MONTGOMERY COUNTY PLANNING DEPARTMENT
THE MARYLAND-NATIONAL CAPITAL PARK AND PLANNING COMMISSION

REVIEW TYPE: Preliminary Plan of Subdivision

PROJECT NAME: Bradley's Choice

CASE #: 120070440

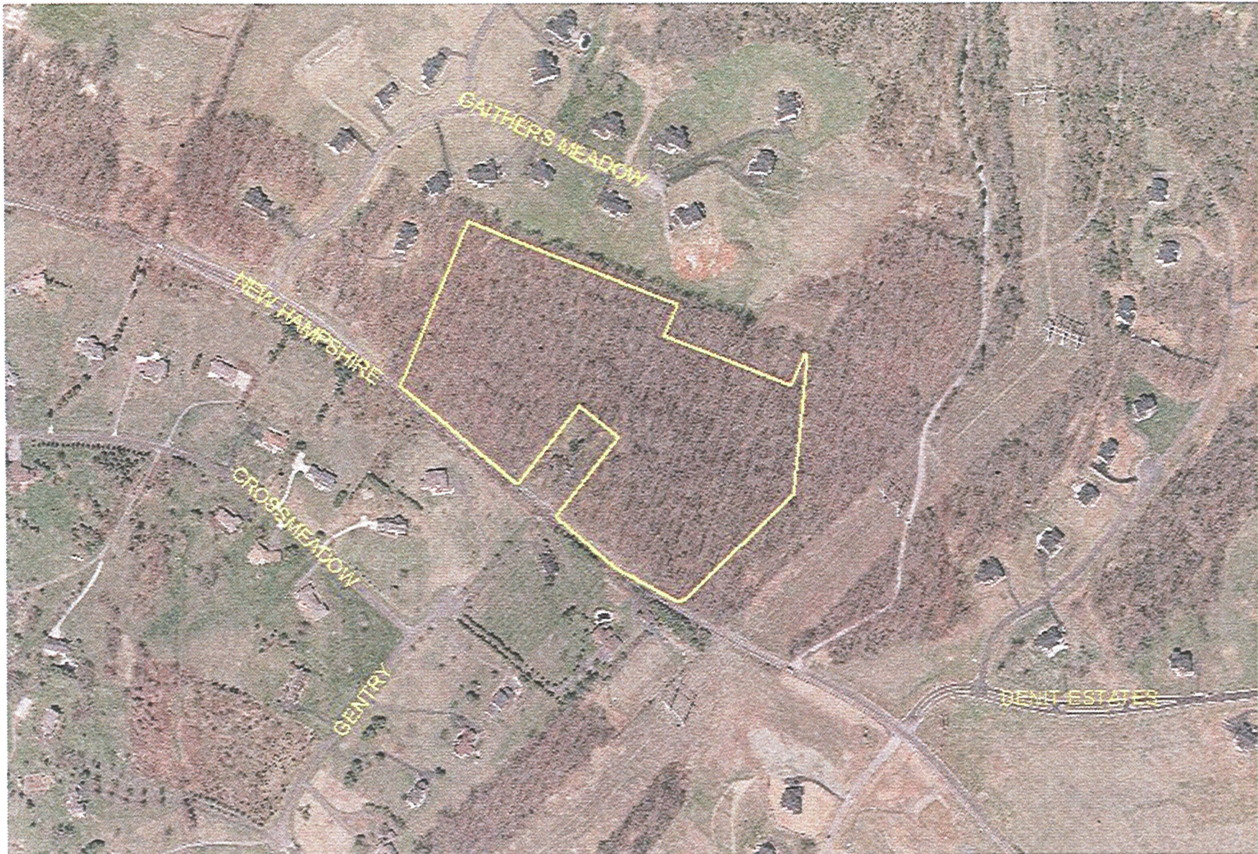
The subject property, pictured below and in Attachment A (Vicinity Map), is a 17 acre unplatted parcel located on the northeast side of New Hampshire Avenue, 500 feet southeast of the intersection with Gaithers Meadow Lane. The site is located within the Rural Cluster (RC) zone. The property is undeveloped, and no structures exist on it. A separately owned parcel that is not a part of this subdivision is surrounded by the subject property on three sides, with the fourth side fronting on New Hampshire Avenue. That separate parcel is developed with a one-family dwelling. The shape of the subject property, with the intervening parcel, creates two separate frontages on New Hampshire Avenue. The site is surrounded by one-family residential lots in the RC zone to the north, south, east and west. A PEPCO right-of-way containing an electrical transmission line is located off-site to the east.
